**Contractor for the Reconstruction of Taxiway NA
at George Bush Intercontinental Airport Houston (IAH)
CSP No.: H37-RTWYNA-2019-002 PN No.: 9007**

**LOC #4 Attachments
for Clarifications No.'s II through VIII
(revised 11-22-2019)**

LETTER OF CLARIFICATION NO. 4 – 11/18/19

3 SPLICE DETAILS
E10-04 SCALE: NTS

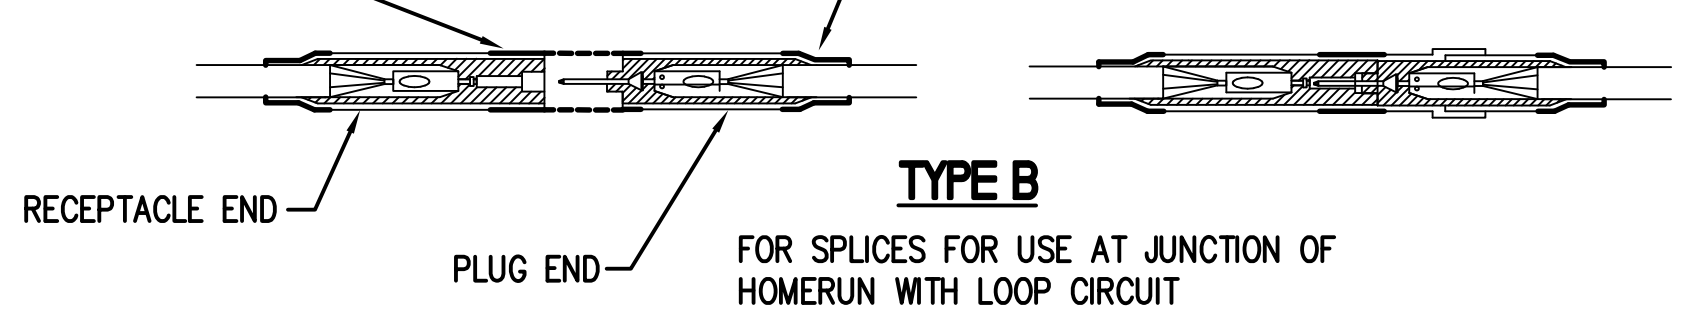
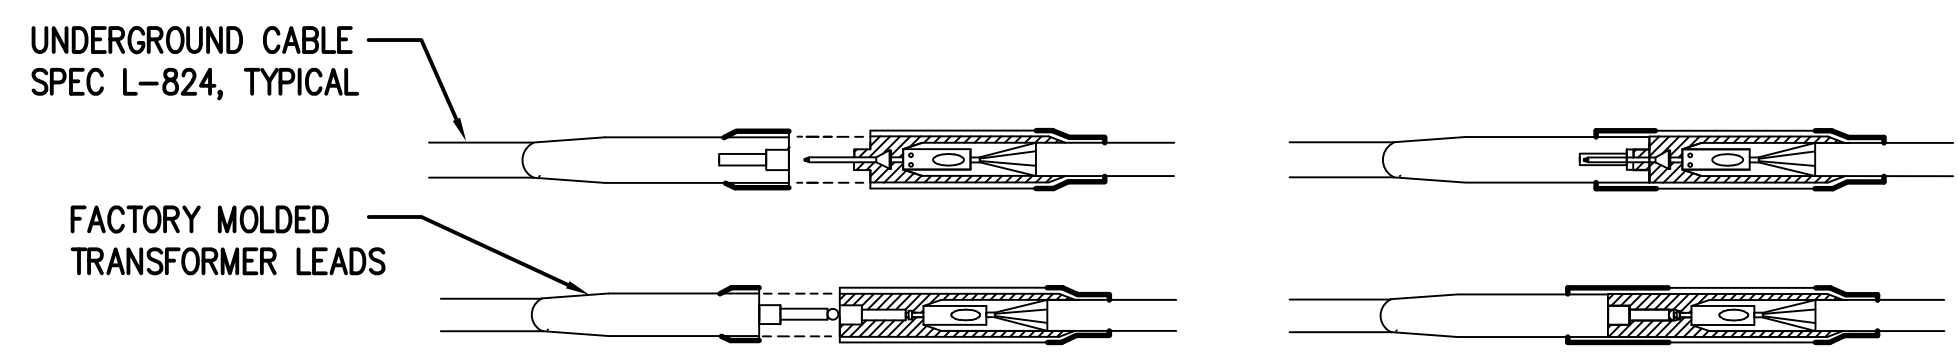
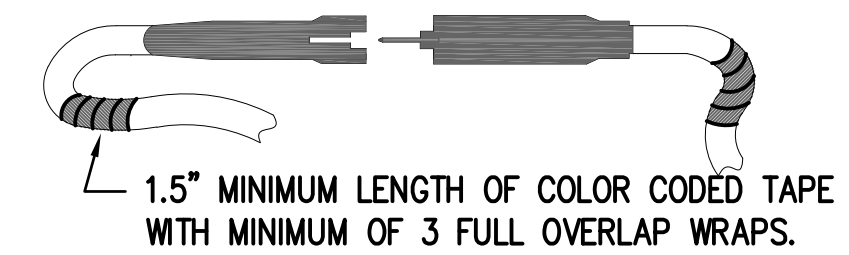
- VIII. **Replace plan drawing E10-04 "ELECTRICAL DETAILS AIRFIELD LIGHTING"** with new drawing E10-04 "ELECTRICAL DETAILS AIRFIELD LIGHTING" showing modification to details 1 and 3 and new detail 6 clarifying label requirements and splice details.

- NOTES:
- PROVIDE STANDARD L-823 KIT FOR SPLICES.
 - PROVIDE COLOR CODED CABLE ID AT EVERY SPLICE IN CANS, PULL BOX, HANDHOLE, AND MANHOLE
